SUBJECT: Provides addl info re NPDES Permit Application PA 0047325, in response to 841022 telcon questions. Info includes revised water use diagram as well as info updating permit application.

November 12, 1984

SUSQUEHANNA STEAM ELECTRIC STATION
NPDES PERMIT APPLICATION SUPPLEMENTAL INFORMATION
PERMIT NO. PA 0047325
CCN 741326 FILE 012-3
PLE-6239

SUSQUEHANNA SES
 WATER USE
 DIAGRAM. (REV. 11/84)

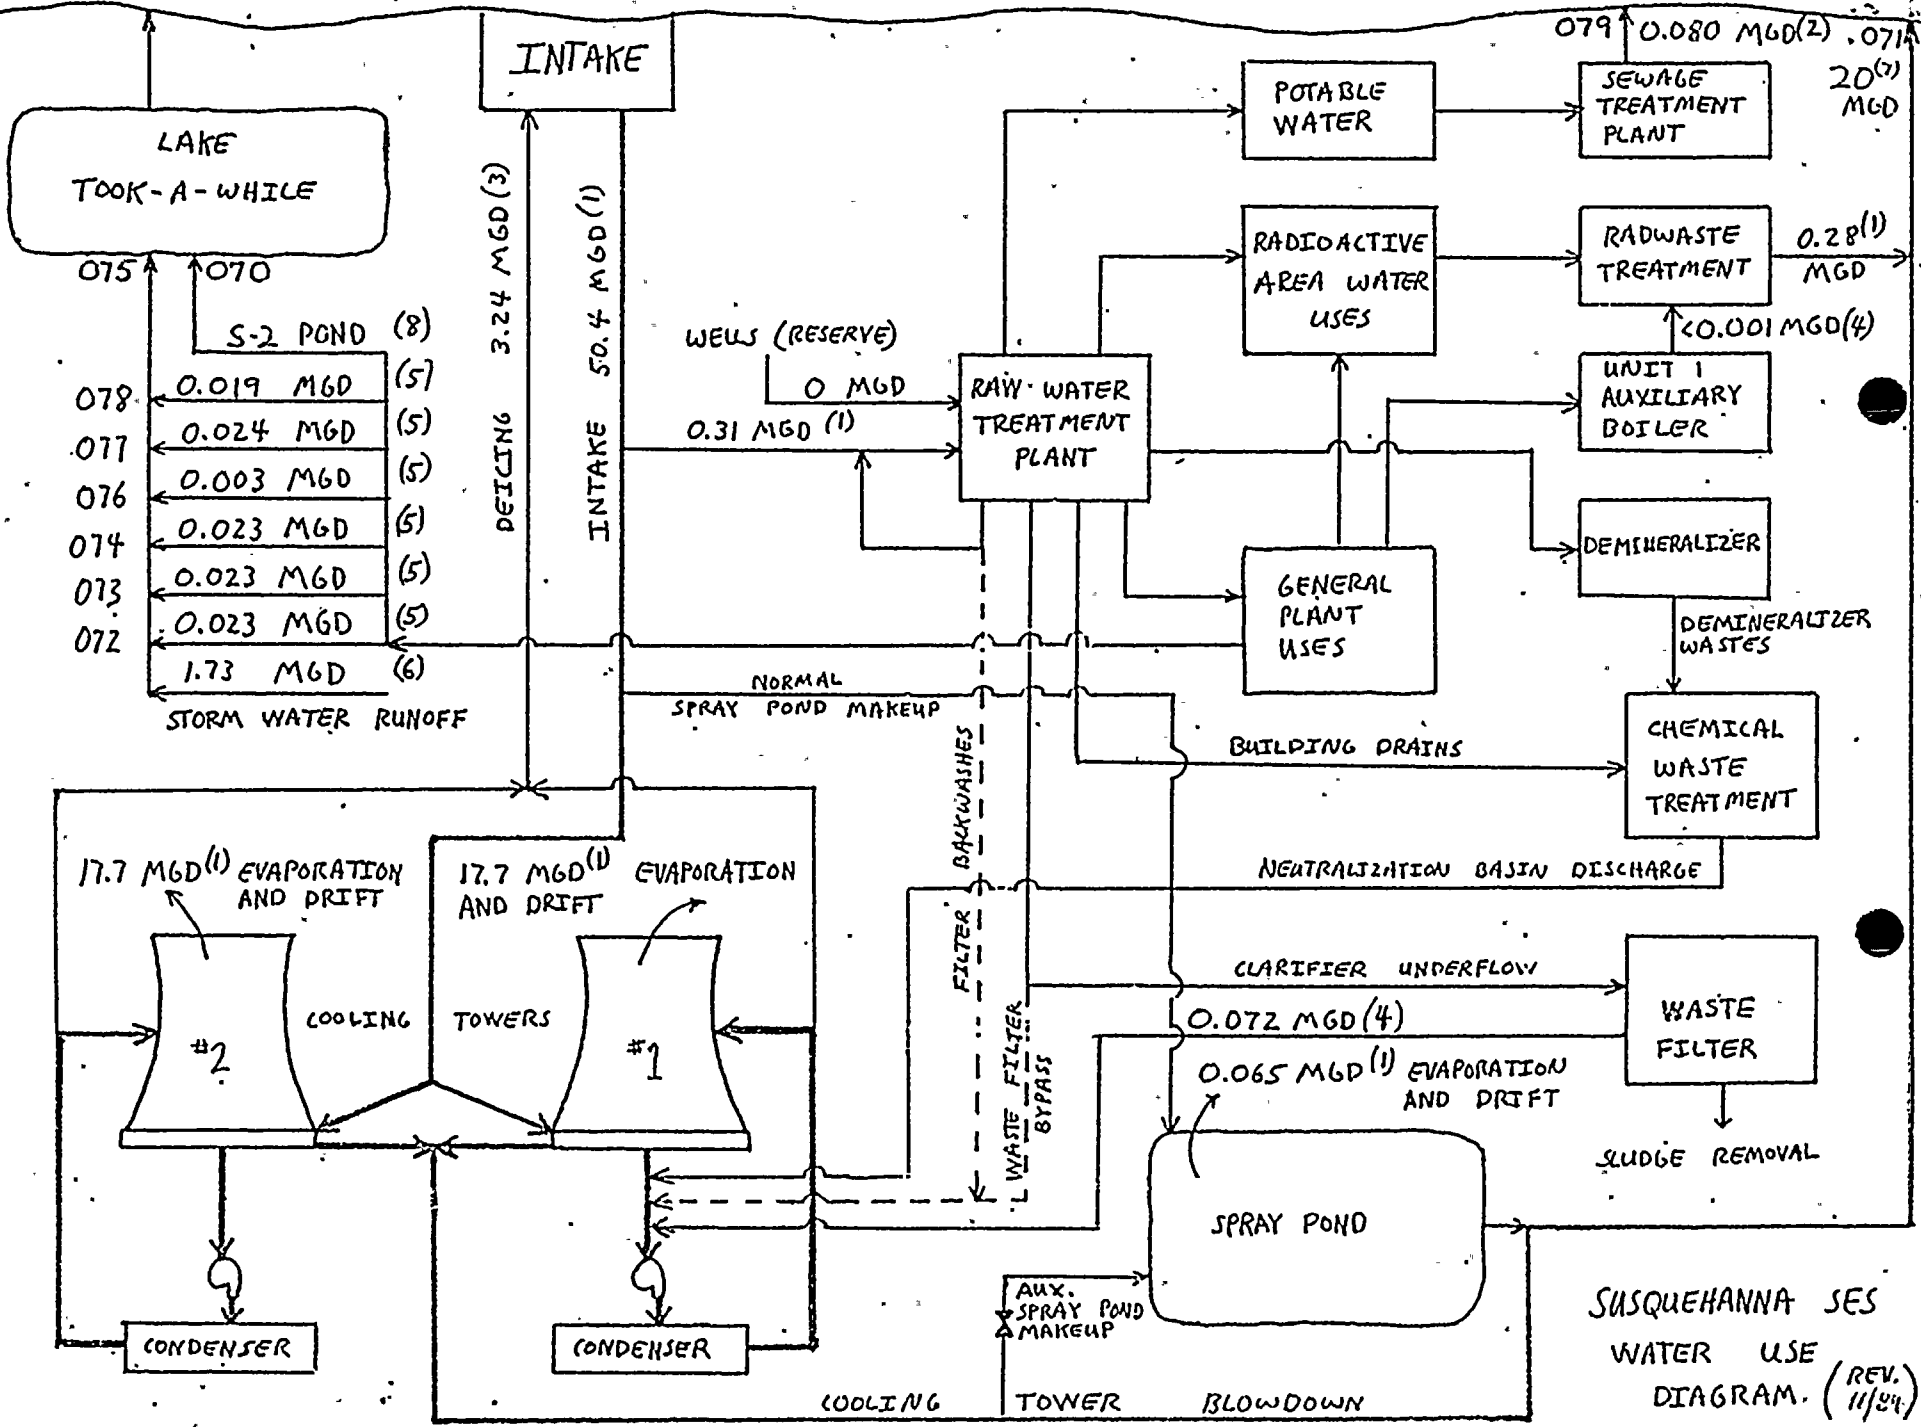
1. Attached is a revised Water Use Diagram which reflects changes that have occurred in plant operation and wastewater discharges since the March, 1984 permit application. Temporary bypasses are shown on the diagram with dotted lines.

- A. As stated in the March, 1984 permit application, the clarifier underflow from the raw water treatment plant is being directed to the circulating water system (circwater), due to waste filter operational problems. Once this system becomes operational, this underflow will be directed to the waste filter where the sludge will be removed for disposal and the water portion returned to circwater.

- B. Backwashes from two filters, a gravity sand filter and a carbon filter used in the raw water treatment plant, combine with the temporary bypass of the waste filter prior to discharge to circwater. These backwashes were originally intended to be returned to the raw water clarifier. However, due to operational changes these backwashes are now being directed to circwater. Since these changes are not finalized, these filter backwashes may be routed back to the raw water clarifier in the future.

- C. Wastewater from chemical waste treatment (neutralization basins) will not be directed to the waste filter as previously indicated. These basins are used to neutralize acids and caustics used in regenerating the demineralizers. Since this effluent contains little suspended solids, this waste stream will be discharged directly to circwater rather than placing an unnecessary hydraulic load on the sludge filter.

5. The deicing line shown on the water use diagram supplies warm water from circwater to a series of nozzles located just inside the intake structure. During cold weather operations, water is sprayed on the traveling bar screens and the intake channels to remove or prevent ice formations. This system represents no discharge to the river, since any water used for deicing purposes is drawn further into the intake structure and then pumped back to the cooling towers with the intake water.

6. The temporary butter tank listed under outfall 078 on Form 2C and under the Supplement to Item II.B. - Further Description of Outfalls - pg. 7, has been removed. Thus, there will be no discharges from this tank.
7. Monitoring at outfall 070, the S-2 sedimentation pond, can be accomplished by sampling at the sedimentation basin's overflow pipe.
8. Makeup to the spray pond normally occurs directly from the intake line as shown on the water use diagram. However, makeup to the spray pond can also occur from the cooling tower blowdown line.
